Access Compliance Report

Public Rights-of-Way

(Curb Ramps)

Intersection ID: 12279	Main Street: S_MINT_ST	Cross Street: W_MARTIN_LUTHER_KING_JR_BV	Location: N
ADA ID: 556D3B125267	Ramp Type: Perp	Initial Pass/Fail: Fail	Overall Compliance: No
Severity Score: 21.25			
Codes/Mitigation Info/Possible Solution		Field Measurements/Component Compliance

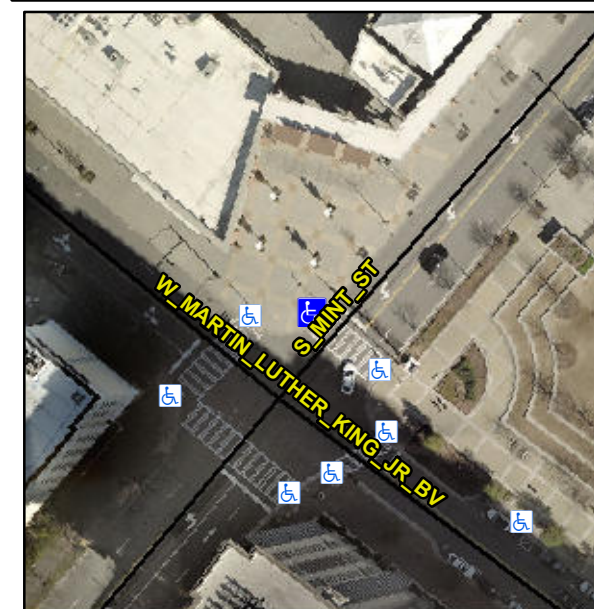
R304.5.1, R304.2.2

Compliance	Description	Data	Compliance	Description	Data
N/A	Ramp Length (in)	78.0	No	Ramp Slope (%)	9.0
No	Ramp Width (in)	47.0	Yes	Ramp XSlope (%)	0.9
N/A	Flare Type LT	N/A	N/A	Flare Type RT	N/A
N/A	Flare Slope LT (%)	N/A	N/A	Flare Slope RT (%)	N/A
N/A	Flare Traversable LT?	N/A	N/A	Flare Traversable RT?	N/A
N/A	Landing Length (in)	N/A	N/A	DWS Provided?	N/A
N/A	Landing Width (in)	N/A	N/A	DWS Contrast?	N/A
N/A	Landing Slope (%)	N/A	N/A	DWS Length (in)	N/A
N/A	Landing X Slope (%)	N/A	N/A	DWS Full Width?	N/A
N/A	Landing Curb? (Y/N)	N/A	N/A	DWS Offset (in)	N/A
N/A	Shared Landing?	N/A			
N/A	Gutter Ponding?	N/A	N/A	Gutter Slope (%)	N/A
N/A	Gutter Lip Ht (in)	N/A	N/A	Gutter X Slope (%)	N/A
N/A	Painted X Walk1?	Yes	N/A	Painted X Walk2?	N/A
	X Walk 1 Direction	To SE		X Walk 2 Direction	N/A
N/A	X Walk 1 Width (in)	171.0	N/A	X Walk 2 Width (in)	N/A
	X Walk 1 Slope (%)	1.0		X Walk 2 Slope (%)	N/A
	X Walk 1 X Slope (%)	1.2		X Walk 2 X Slope (%)	N/A

Remove & Replace Entire Ramp.
